# **Intel® Mobile Pentium® III Processor Specification Update**

Release Date: March 2001

Order Number: 245306-017

Figure 7. BCLK Timing Waveform

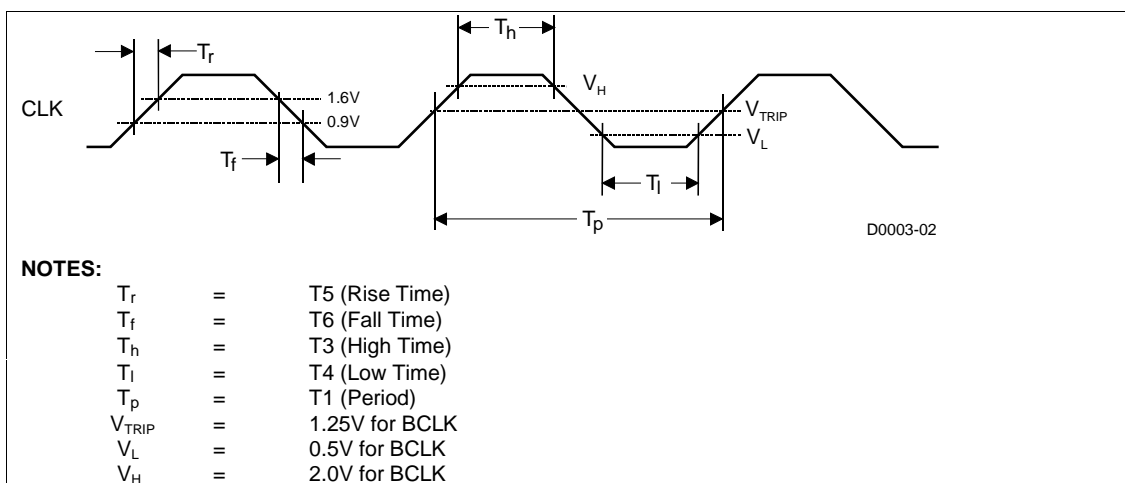
For B0 step processors, the  $V_{IH,BCLK}$  Min spec is changed to 2.0V (from 1.7V for A2 step) and  $V_{IL,BCLK}$  Max spec is changed to 0.5V (from 0.7V for A2 step). Due to this, new values are specified for BCLK high and low times for B0 step processors. These modifications affect corresponding specs in Table 13, Table 14, Table 24, and Figure 7 in *Mobile Pentium® III Processor in BGA2 and Micro-PGA2 Packages datasheet* (Order Number 245302-002).

The following tables and figures highlight the above mentioned BSEL[1:0] and BCLK specs modifications made for B0 step processors:

| Symbol | Parameter             | Min   | Typ | Max       | Unit | Figure   | Notes         |
|--------|-----------------------|-------|-----|-----------|------|----------|---------------|
| T3     | BCLK High Time        | 2.70  |     |           | ns   | Figure 7 | at >2.0V      |
| T4     | BCLK Low Time         | 2.45  |     |           | ns   | Figure 7 | at <0.5V      |
